**ADDENDUM 02**

Addendum #	02	Date Issued	04/01/2022
Project Name Job #	FB&T Arena and SJM Additions and Renovations – Bid Package 01	EAPC Project 20191170 OSE #R0319--23X/FBT	
Bid Date Time	04/07/2022	2:30pm

***SDSU First Bank & Trust Arena
Addition & Renovation
(Bid Package #1)***

DRAWING TITLE
STRUCTURAL SCHEDULES

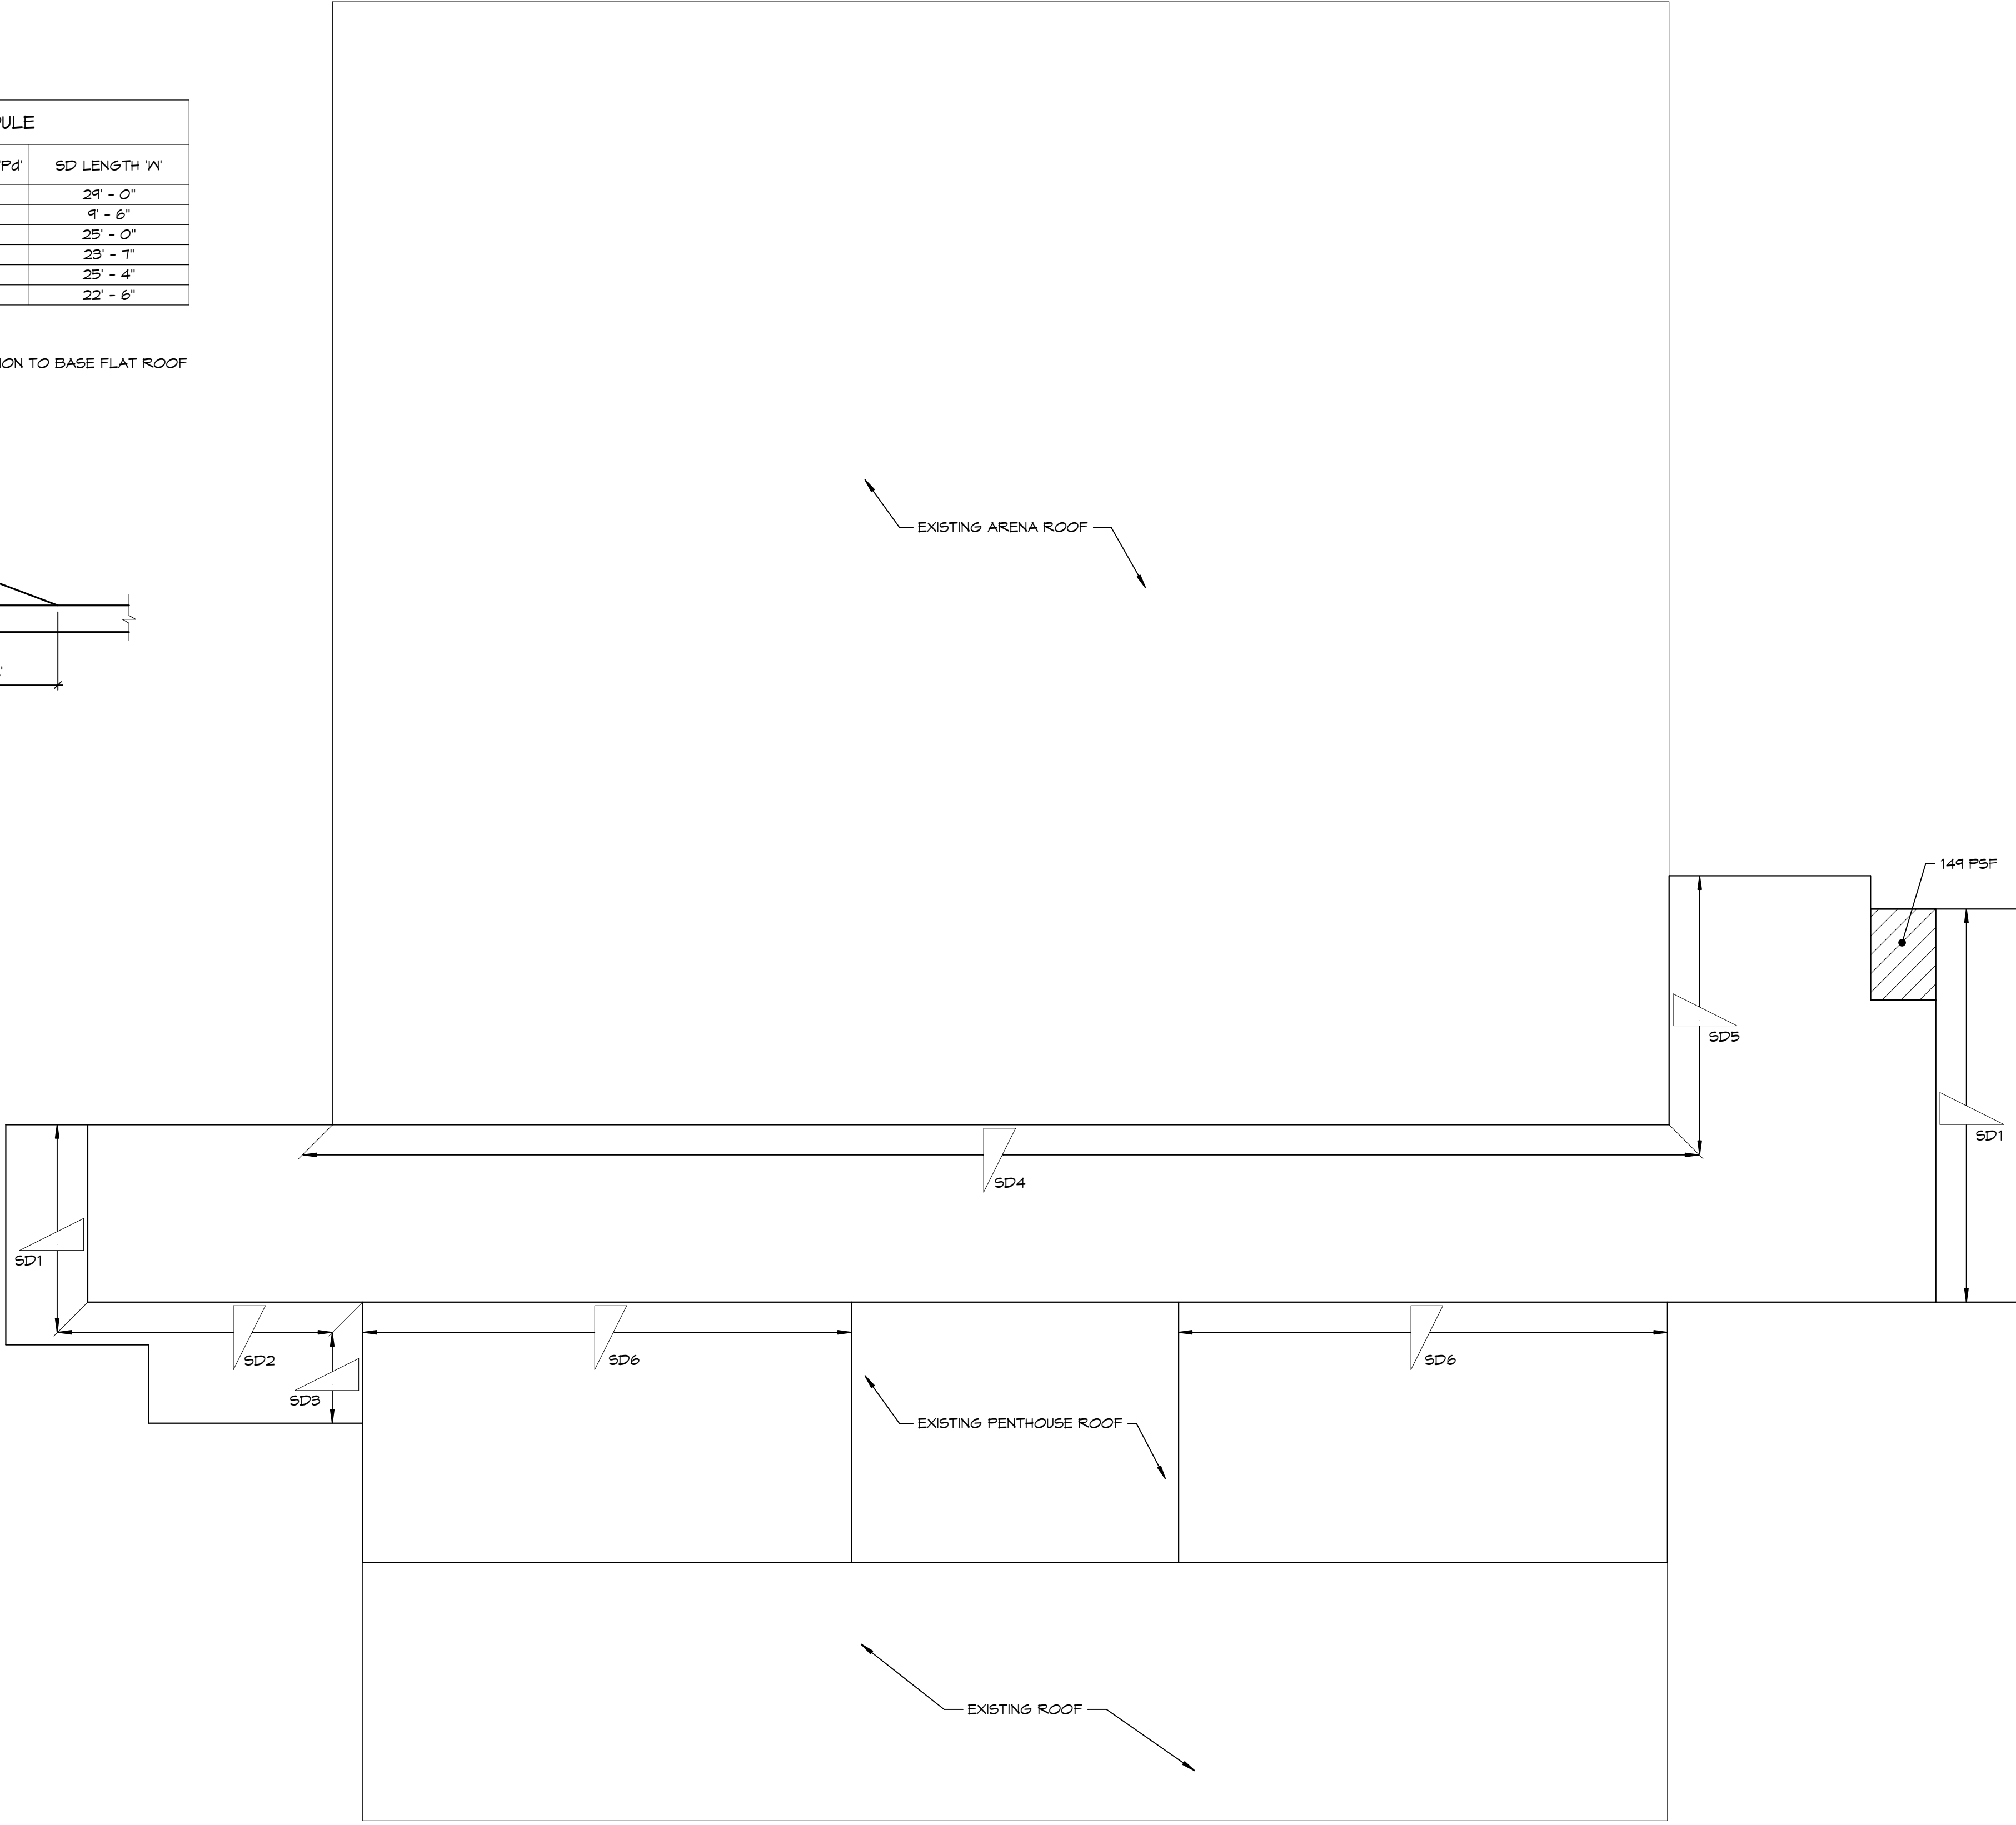
S002	Revise footing schedule per attached S002
S101A	Add generator enclosure details per attached S101A
S101B	Revise wall thickness per attached S101B
S101C	Revise elevator shaft per attached S101C
S101D	Revise hydrotherapy area per attached S101D
S201B	Add sheet note "5" per attached S201B
S201C	Add sheet note "5" and Keynotes 32 and 33 per attached S201C
S202A	Add sheet note "7" per attached S202A
S202B	Add sheet note "7" per attached S202B
S202C	See attached S202C for various note and framing revisions
S202D	Add sheet note "7" per attached S202D
S203C	Revise framing around elevator shaft per attached S203C
